AGENDA VIRTUAL BIRMINGHAM DESIGN REVIEW BOARD MEETING

SUBJECT: 470 N. Old Woodward – Design Review (All Updates in Blue Text)

In response to your review dated June 3, 2020 and the comments of the board attendees at the June 3, 2020 meeting, we are submitting attached revised drawings A001, A101, A201, and A202 as well as a revised material/finish sample board to specifically address the concerns regarding the suspended planter, as well as some additional changes to coordinate with the new pergola that replaces the planter element. Please note the following modifications on the attached drawings to the previously submitted proposal:

South (Front) Elevation

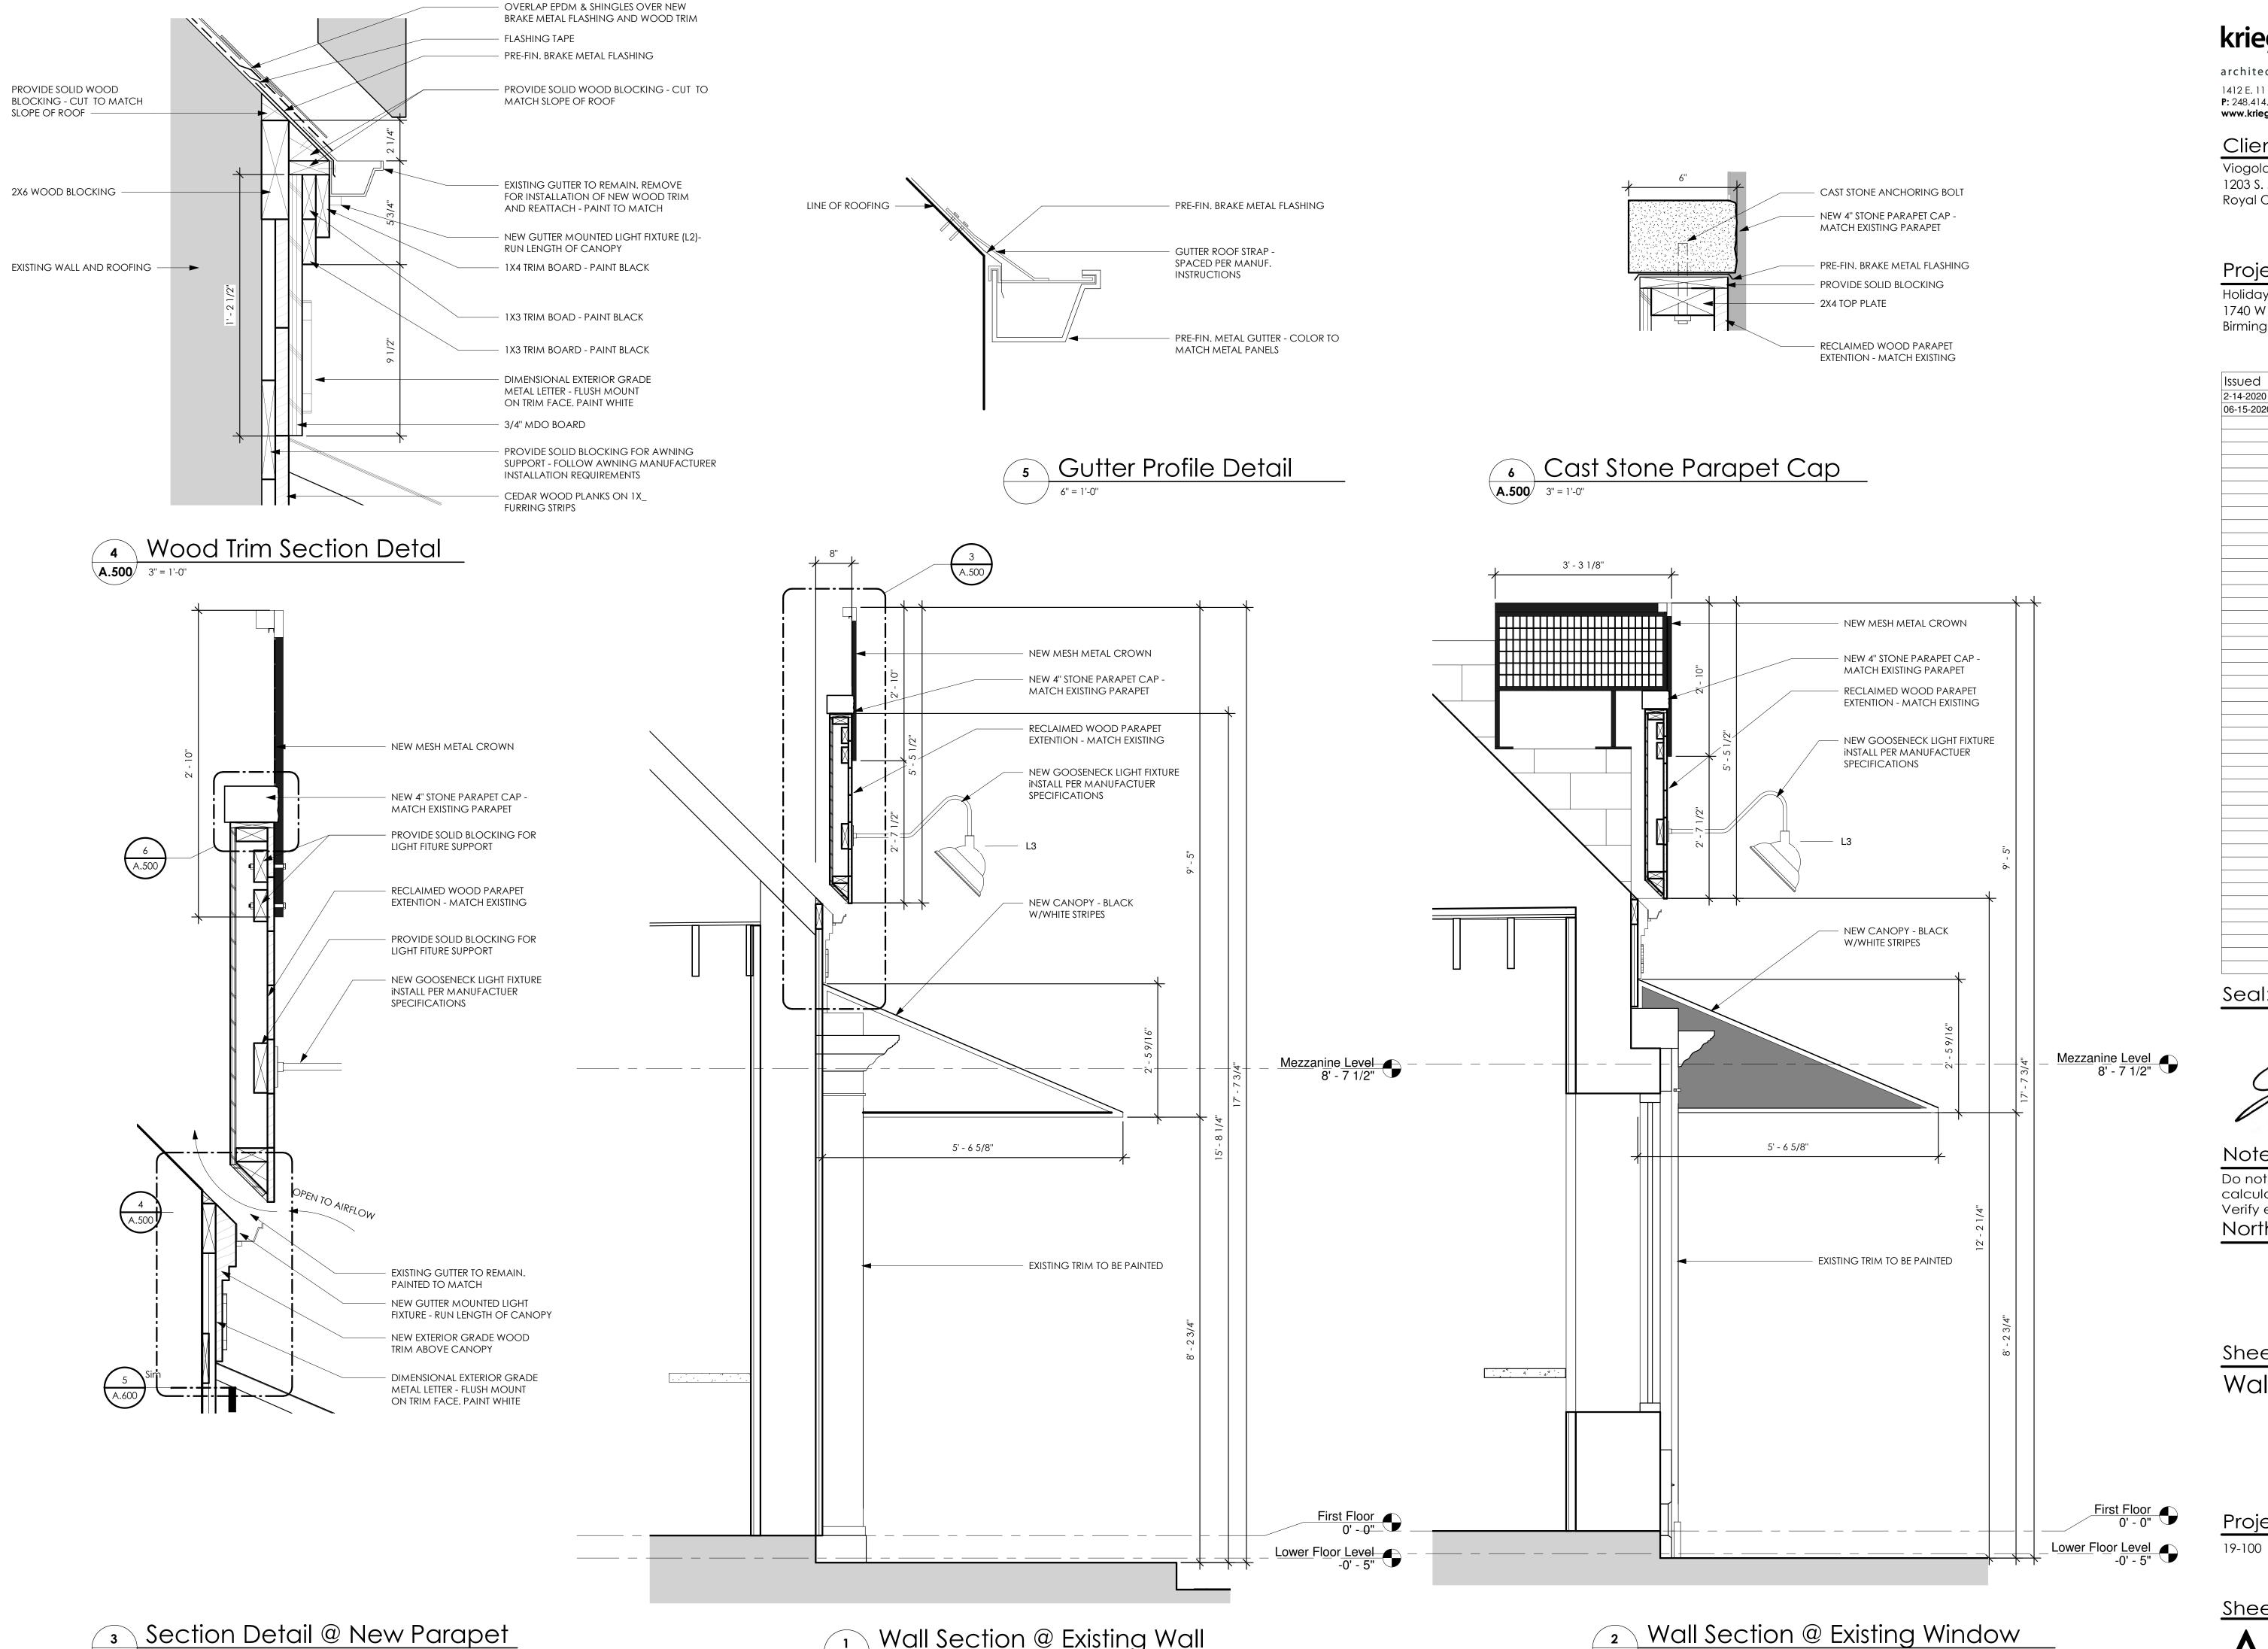
There are some discrepancies across several of the plan sheets that must be resolved in terms of quantity and specifications in regards to the proposed wall sconces. The rendering-based design set shows 3 proposed wall sconces, and the material table at the end states that the manufacturer is Cooper Light. The architectural drawings (Sheet A.200) show only 1 wall sconce on the elevation drawings, and show the manufacturer as Cylinders. Finally, the photometric plan shows only 2 wall sconces, and has the manufacturer as Cylinders.

In summation, the applicant must submit revised site & photometric plans showing consistent lighting information and illumination levels that do not exceed 1.5 foot-candles at the east/west property lines and 5 ft. beyond the front (south) property line.

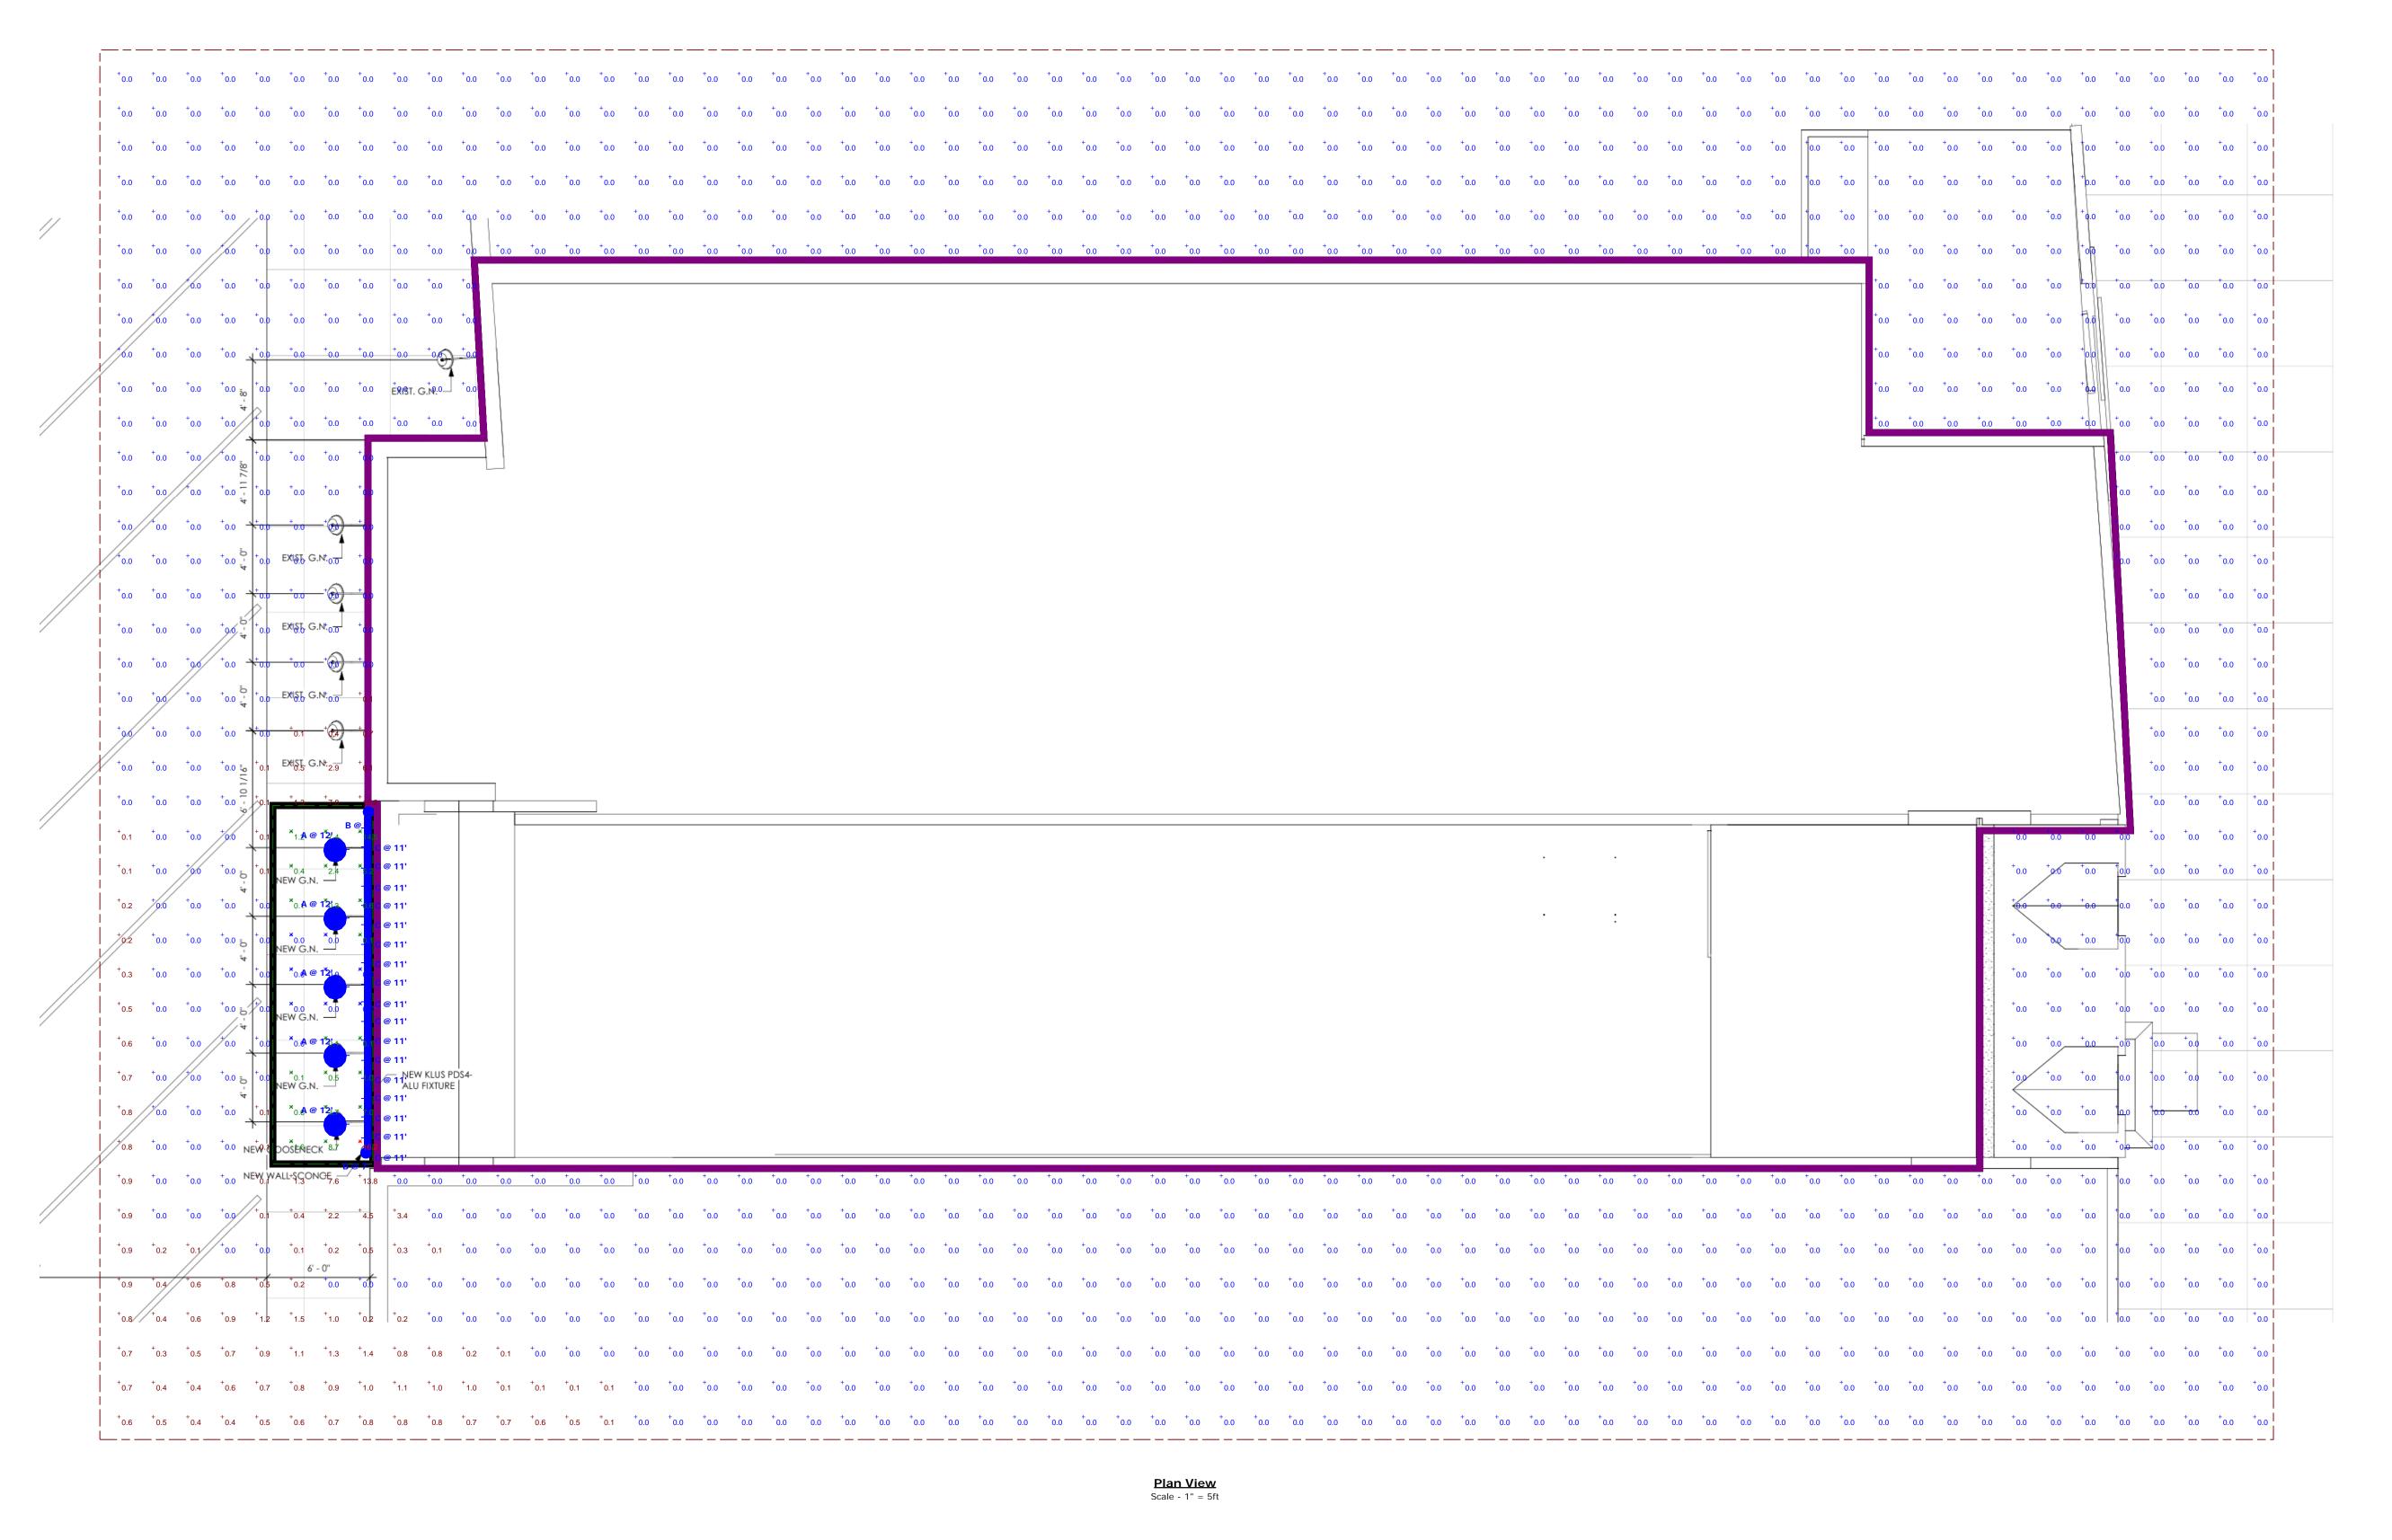
As required, the applicant has submitted a photometric plan documenting the illumination levels at the property line of the proposed project site. There exist a couple of issues with the photometric plan provided:

- 1. The photometric plan does not show the light fixtures proposed at the top of the mesh metal crown. Although this lighting will be unlikely to affect the light levels at the property line significantly, all fixtures are required to be shown on the photometric plan. Additionally, the plan only shows 2 wall sconces where 3 seem to be proposed.

- 2. The illumination levels were not calculated correctly. The photometric plan notes that the calculations are shown in foot-candles at 0 ft. 0 in. Article 4, Section 4.21 of the Zoning Ordinance requires light intensity to be measured at 6 ft. above ground level on a vertical plane.

- 3. For this project, the illumination levels shall not exceed 1.5 maintained foot-candles at any property line. The intensity of light on a site which provides a front setback of less than 5 ft. shall be measured from 5 ft. beyond the front property line. The subject buildings fit this criteria. Although the photometric plan is not to scale (not uncommon), the site plans show the canopy at a 5 ft. 7 in. extension, which we may use as a rough reference. Using the canopy, it appears as though there is at least one figure that may currently exceed the illumination levels permitted in that area at 1.6 foot-candles (east side of canopy). When a new photometric plan is submitted, there are likely to be more issues. There are also some high foot-candle measurements as the measurements continue east and/or west.
